Project No. 112G00352

RE: **Final**
Response to United States Environmental Protection Agency (EPA) E-Mail Comments
Dated April 10, 2008 on Interim Measures Work Plan (IMWP) for Solid Waste
Management Unit (SWMU) 13 (Mine Fill B)
Naval Surface Warfare Center (NSWC) Crane
Crane, Indiana

**RESPONSE TO COMMENTS (RTCs) DATED APRIL 10, 2008
FROM UNITED STATES ENVIRONMENTAL PROTECTION AGENCY (EPA)
(E-MAIL FROM PETER RAMANAUSKAS)
ON THE INTERIM MEASURES WORK PLAN (IMWP) RTCs DATED DECEMBER 20, 2007
FOR SWMU 13 – MINE FILL B
NAVAL SURFACE WARFARE CENTER
CRANE, INDIANA**

- Legend**
- Excavation Area Node
 - Road
 - Railroad
 - - - Fence
 - Wall
 - Stream/River
 - Vegetation
 - Topographic Contour
 - IMWP Excavation Limits
 - Limit of Additional Option 2 Excavation
 - Building
 - Concrete Slab
 - Option 2 Excavation Area
 - Culvert

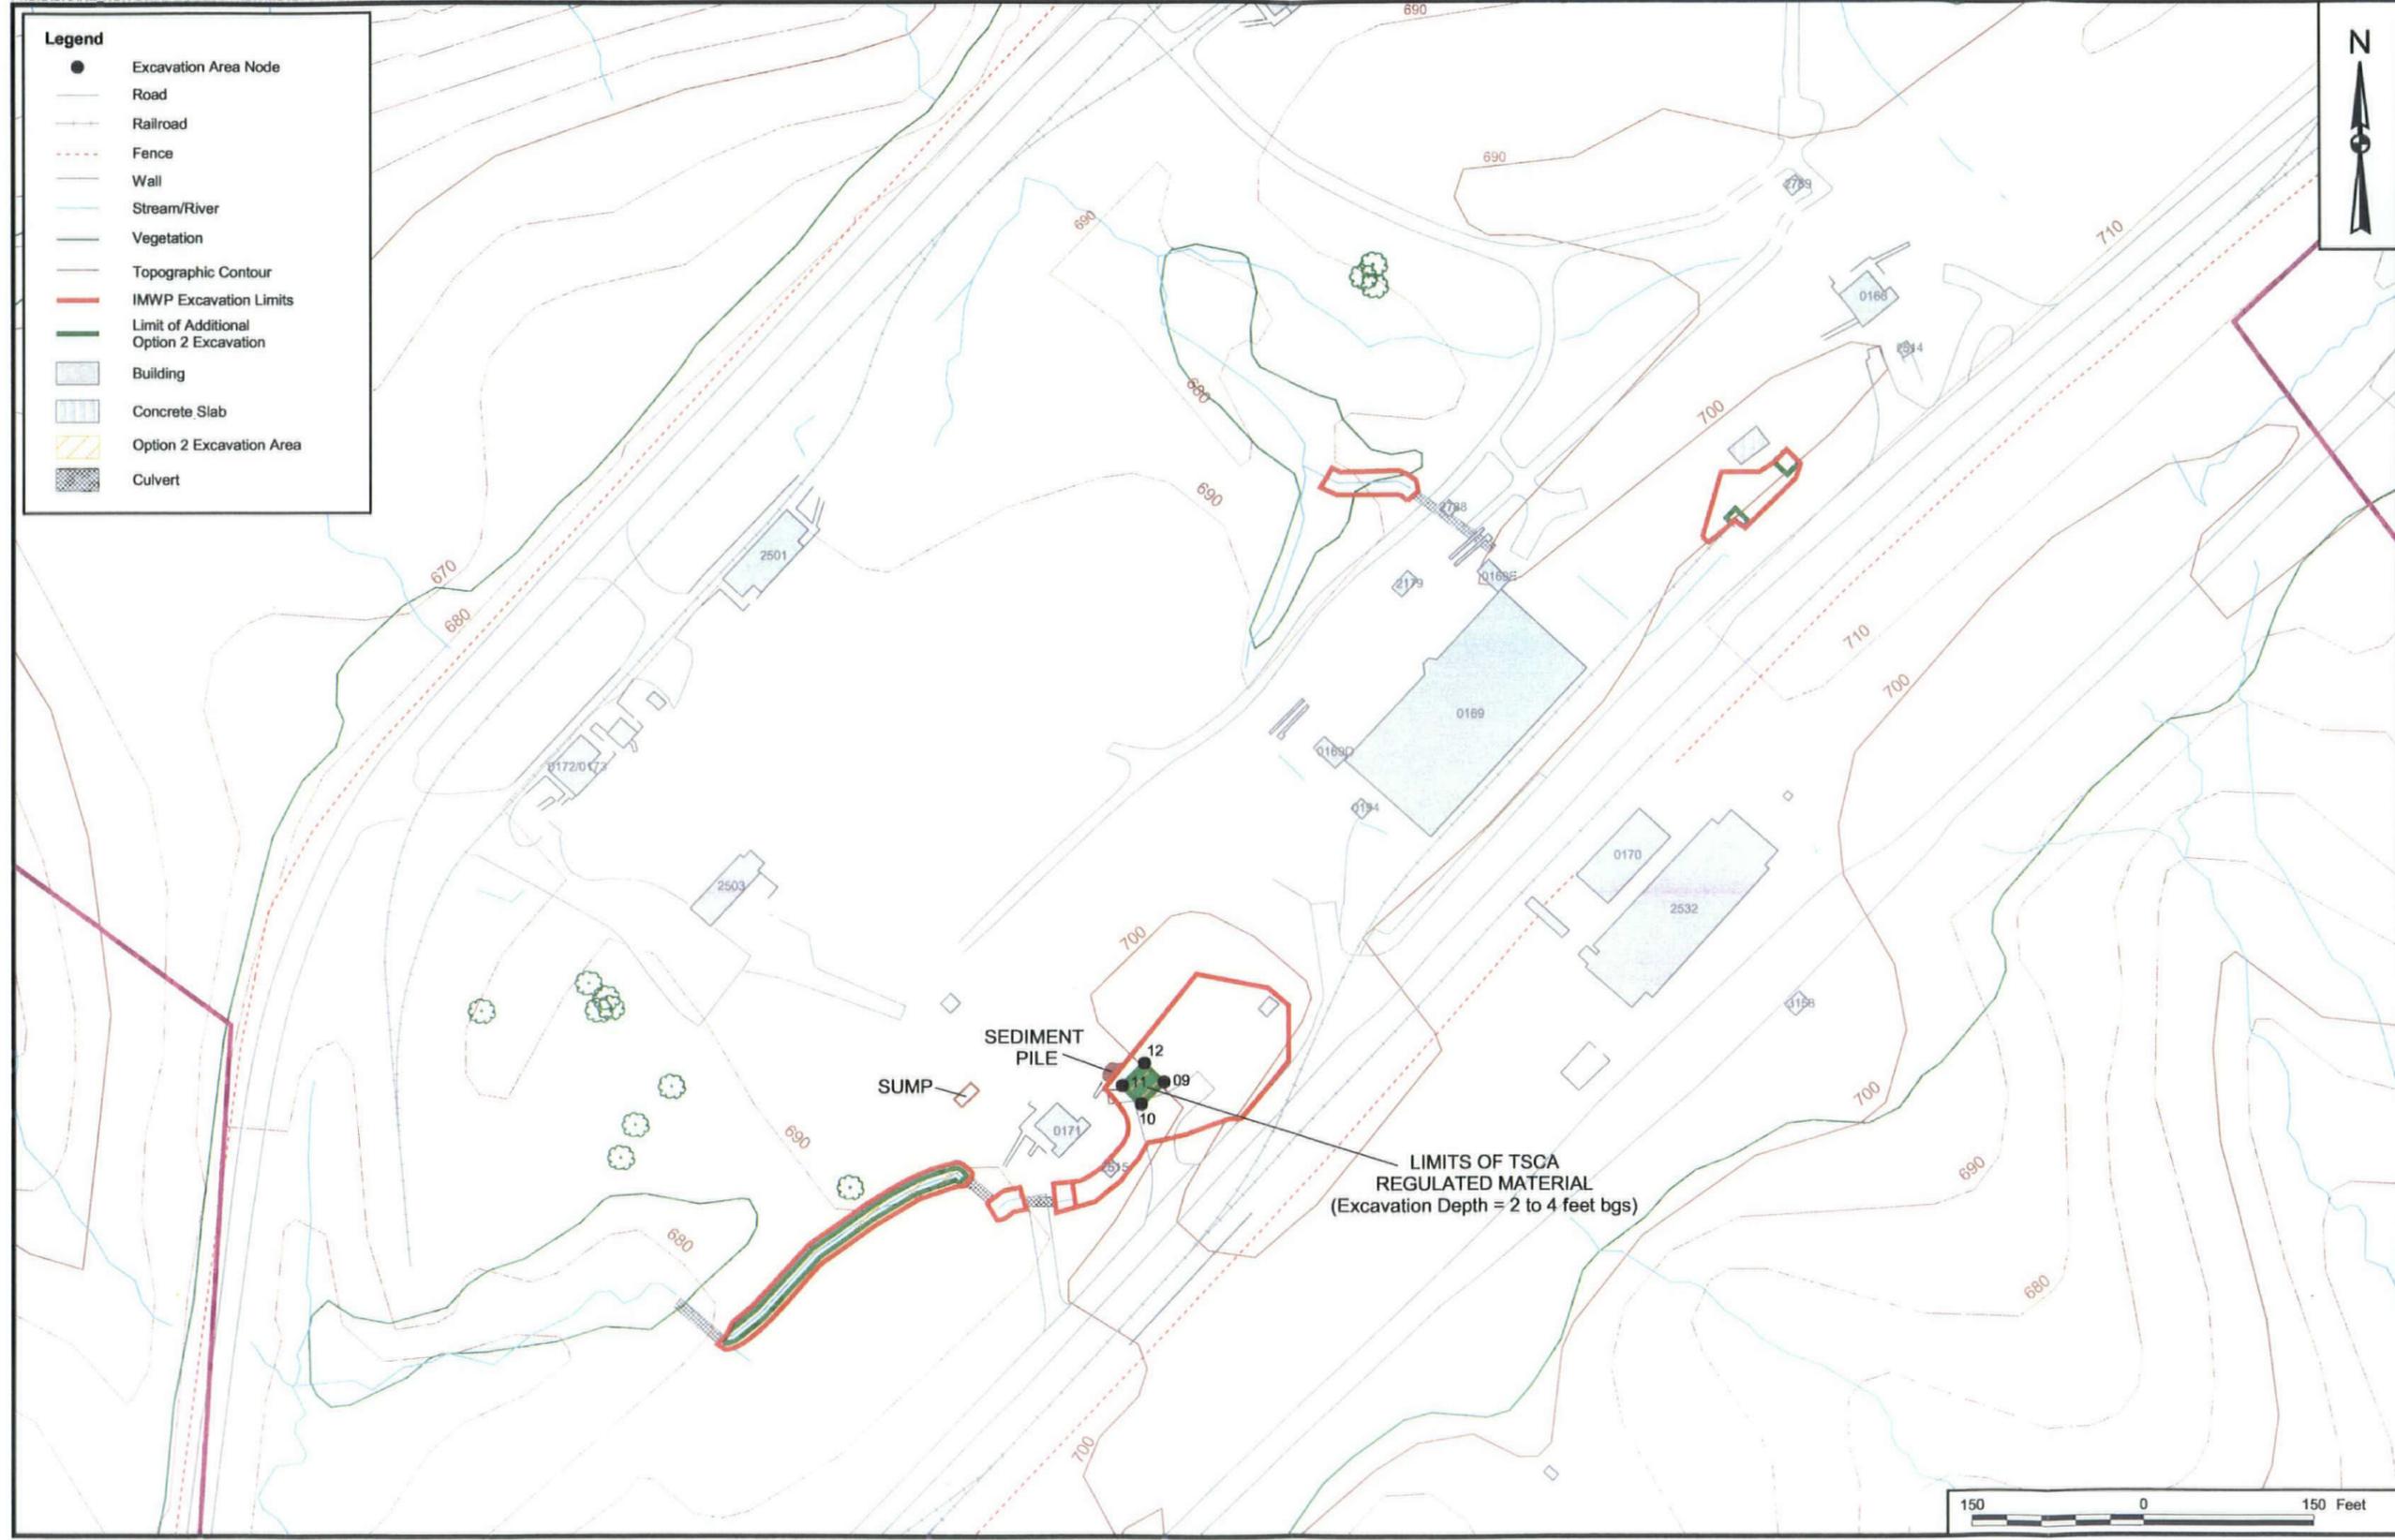
Response 1c does not address the comment. Overall, the text remains confusing with respect to which buildings were known to have PCB use and which buildings are having PCB contaminated soil removed. For example, Section 3 describes work around B-169 and B-171 but does not talk about B-166 while Figure 3-1 shows work proposed around B-166. Some places in the text discuss B-166/171 and others B-169/171. Please describe work taking place at all three buildings and what the sources of PCB were at each building. If a building did not have a source of PCB, describe how PCB came to be located near the building.

Response to EPA-1 (4-10-08): Figures 3-1, 3-2, and 3-3 indicate a fenced area northeast of Building 169 with "0166." This area is a fenced in area where the former Building 166 Therminol Boilers were located. The Therminol Boilers for Building 166 and Building 171 are believed to be the sources of polychlorinated biphenyl (PCB) contamination at SWMU 13 (Mind Fill B). PCB activities did not occur at Building 169. The purpose of referencing Building 169 is as a landmark for the remediation Environmental Multi Award Contractor (EMAC). The Navy believes that it is appropriate to use Building 169 as a landmark because of its location relative to the proposed remediation areas.

For clarification, Figure 3-1, 3-2, and 3-3 (See Attachment 1) have been modified to include a legend for the former foundation pad of the Therminol Boilers rather than fenced areas. Additionally, these figures have been modified to show Building 166.

EPA-5c (4-10-08): Sediments must be tested for PCB concentration for disposal characterization prior to any consolidation. > 50 ppm and < 50 ppm materials should be kept segregated.

Based on the available analytical data, 6 sample locations contain total-PCBs at concentrations that exceed 50 mg/kg. Figures 3-1, 3-2, and 3-3 have been revised to indicate the locations of the soils that must be stockpiled separately for disposal at a TSCA regulated landfill. Additionally, the text and volume tables have been updated to indicate the inclusion of material to be disposed at a TSCA regulated landfill. Additional sampling for disposal will be performed based upon requirements of the selected landfill.

FIGURE 3-4

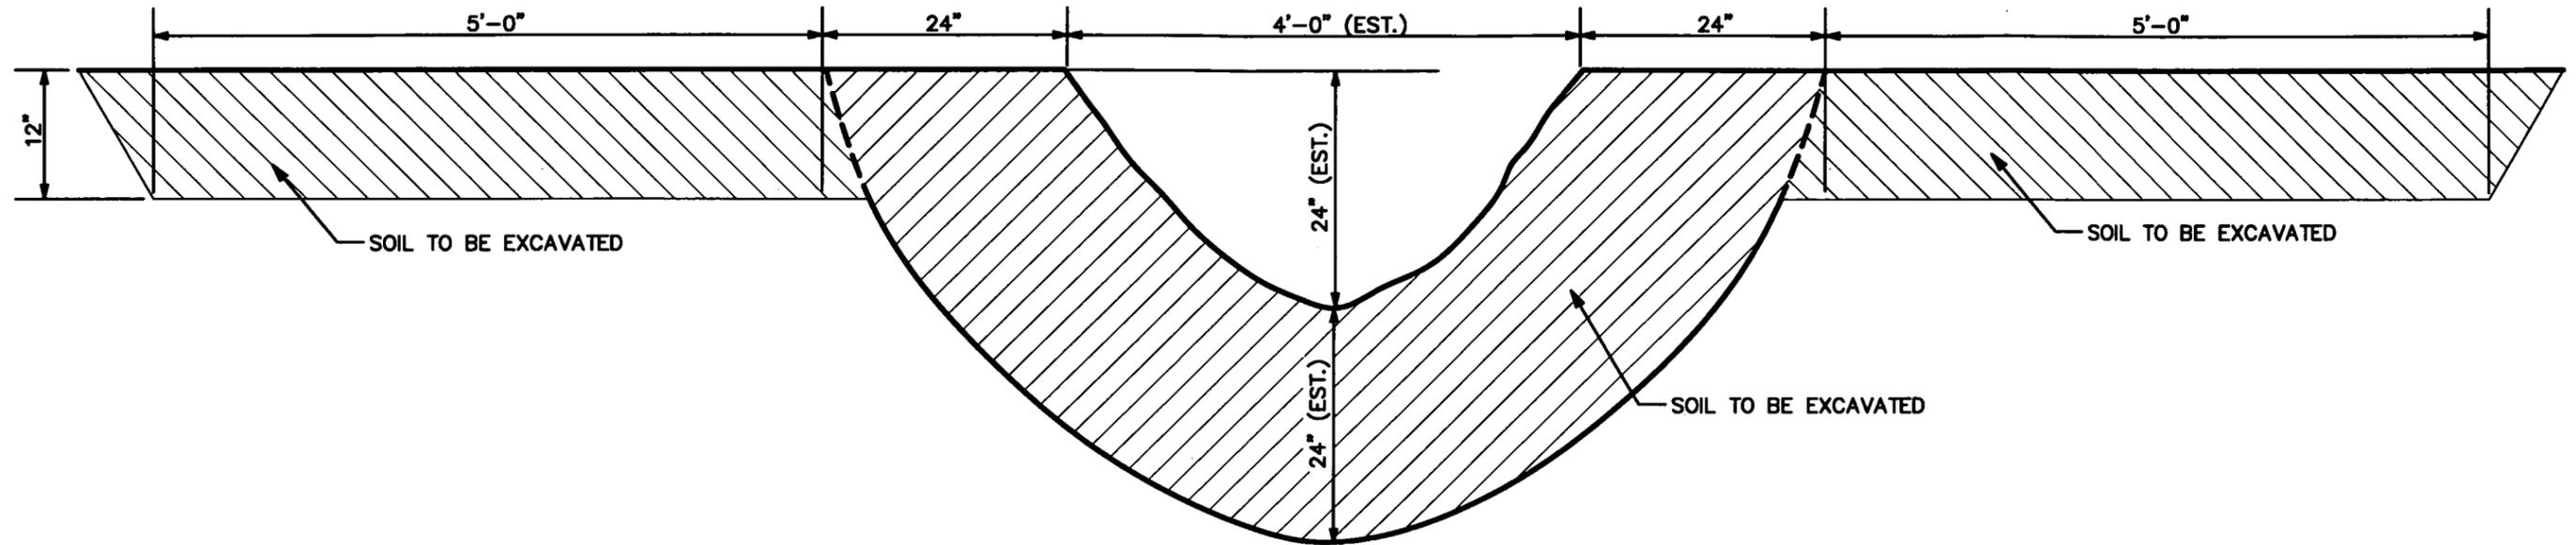
The Navy must take confirmation floor samples. The configuration of the drainage channel or excavation does not eliminate the requirement for confirmation sampling. Please propose a confirmation floor sampling plan.

Response to EPA-6(4-10-08): The excavation shape related to the drainage channel excavation is an irregular shape (see Figure 3-4 in Attachment 2). As a result of the irregular shape, verification samples will be collected from the exposed excavation floor of the channel overflow areas located on each side of the "V / U" shaped channel. Within the "V / U" shaped channel one verification sample will be collected from each of the exposed surface defining the sides of this "V / U" shaped excavation. To illustrate the locations of verification sample collection, a new figure (Figure 5-1 see Attachment 3) has been added to the text and is provided as part of this response to comment document.

- For the soil excavation areas, every 25 foot by 25 foot (e.g., 1 composite sample for every 625 square feet).
- For the channel excavation area of the drainage trenches, every 100 foot of excavation length. These excavations are approximately 6 foot by 100 foot (see Figure 3-4) (e.g., 1 composite sampler per 600 square foot).
- For the channel-overflow excavation area of the drainage trenches, every 100 foot of excavation length. These excavations are approximately 5 foot by 100 foot (see Figure 3-4) (e.g., 1 composite sampler per 500 square foot).

- *"Drainage Channel Excavation Areas - Verification samples will be collected from the excavation sidewalls and floors. Due to the irregular shape of the drainage channel excavation (see Figure 3-4), two verification samples will be collected from the exposed overflow floor areas located on each side of the channel (i.e., from the channel overflow areas) and two verification samples will be collected from the exposed surfaces of the drainage channel (Figure 5-1). Verification samples will be composite samples as described in the QAPP (TtNUS, 2006). These four composite samples make up one set of verification samples. At a minimum, one set of verification samples will be collected from each drainage channel segment and for every 100 linear feet of drainage channel excavation. In the event that a drainage pipe is encountered during the drainage channel excavation process, the frequency of verification sample collection will be increased to one set of verification samples for every 25 linear feet of drainage channel excavation. Therefore, based on the proposed length of drainage channel excavation within 100 feet downstream of the piping outlet areas, if drainage pipes are not encountered, seven sets*
